MPO Staff Response to 19th Street Neighborhoods Coalition submitted by Michael Almon on February 22, 2017

re: DRAFT 2017 MPO-KDOT-FHWA Roadway Functional Classification Map - 23Feb17

DRAFT 2017 MPO-KDOT-FHWA Roadway Functional Classification Map Lawrence-Douglas County, Kansas

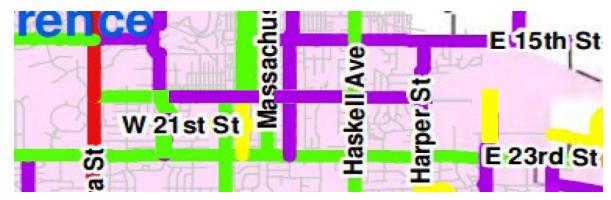
1) Amend the Functional Classification Map (FCM) to return 19th St. to Local classification, Harper to VPB

On this month's MPO agenda is "Action Item 7: Review and Approve the Functional Classification Map Revision (attached)". In spite of our request $7\frac{1}{2}$ months ago, the Draft 2017 Functional Classification Map still has 19th St. from Harper to VBP classified as a Major Collector.

System planning as part of the Transportation 2040 for 19th Street justifies 19th Street as a collector status on the Functional Classification map.

MPO staff does not recommend on down classifying 19th St. from Harper to Venture Park.
